68-76 Marginal Way

Bayside office Building

Atlantic National Trust

**Subject: Bayside Site Development
Response to City's Review Comments**

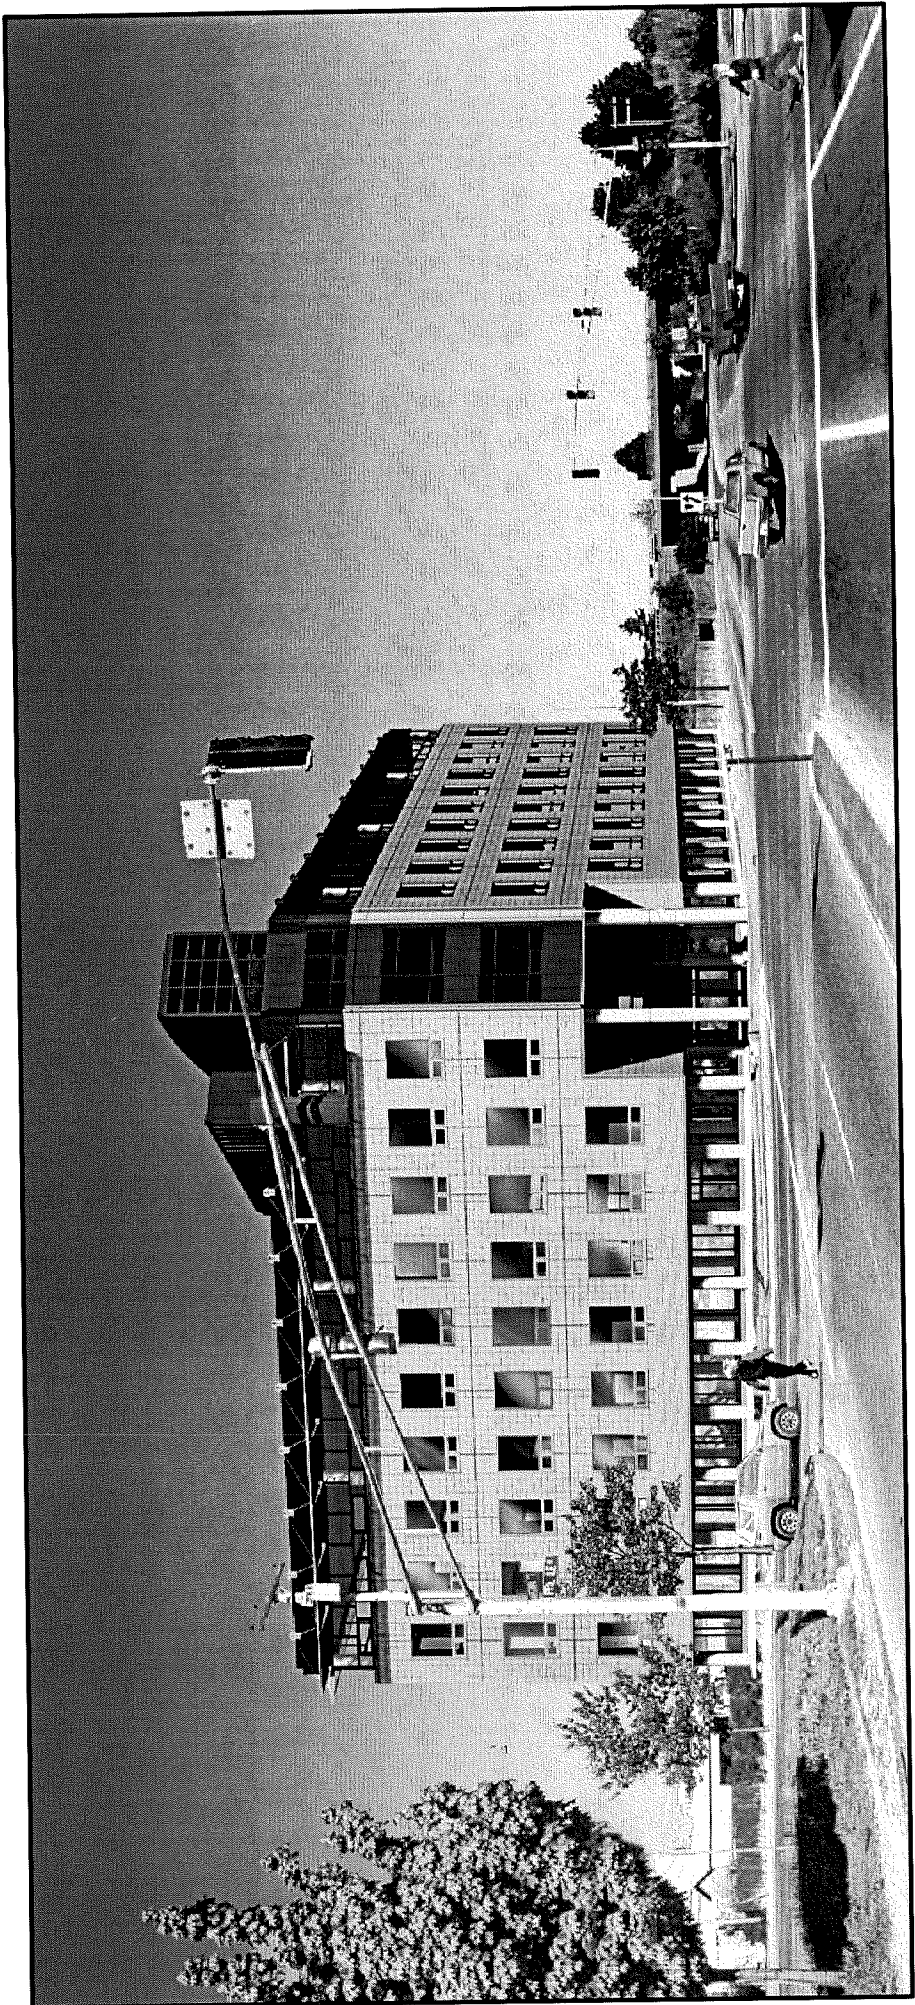
12. SEE SPECIAL B-5 SITE PLAN STANDARDS SEC. 14-526 (2c)

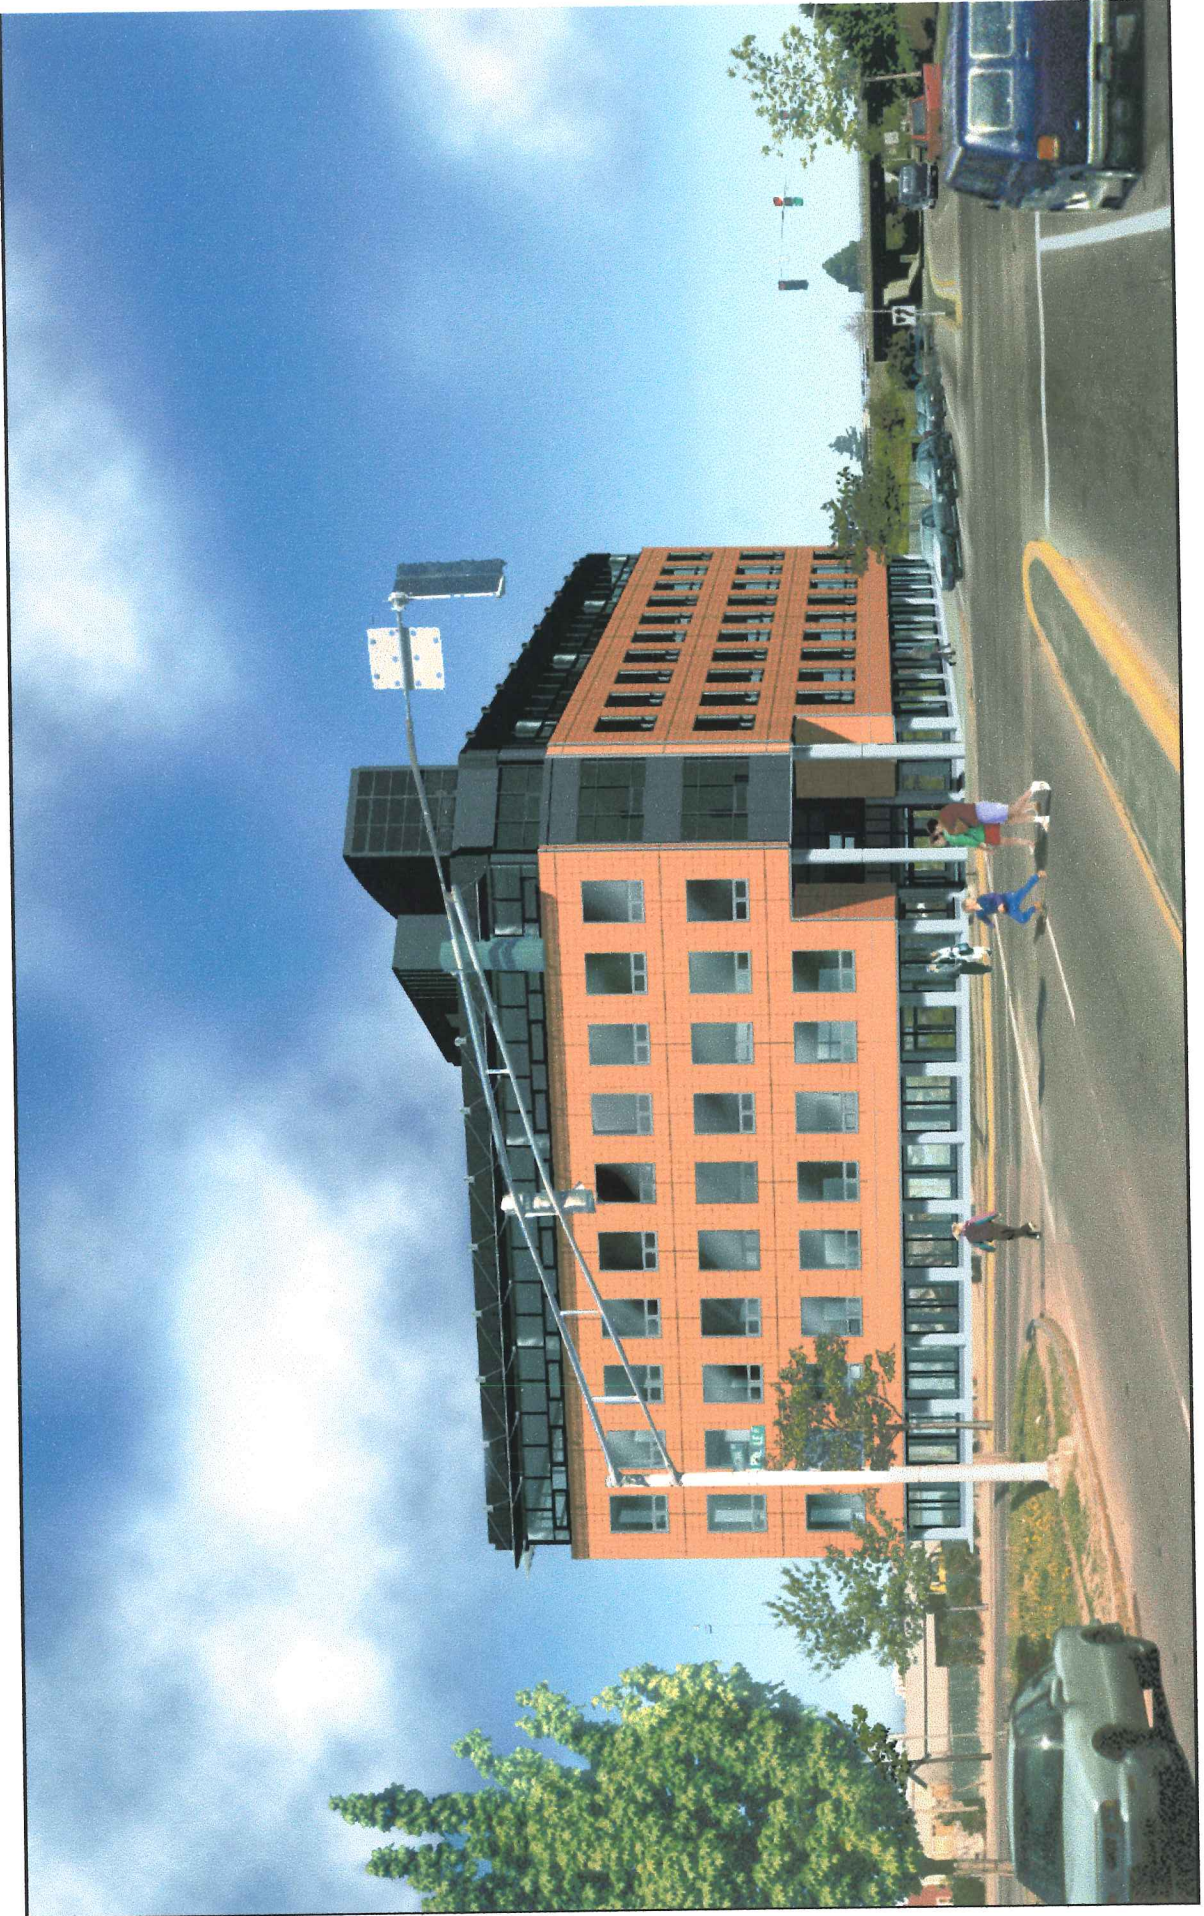
13. IS THE BUILDING WITHIN THE STREET R-O-W? PLEASE CLARIFY

14. YOU DON'T NEED A PLANNING BOARD SIGNATURE BLOCK.
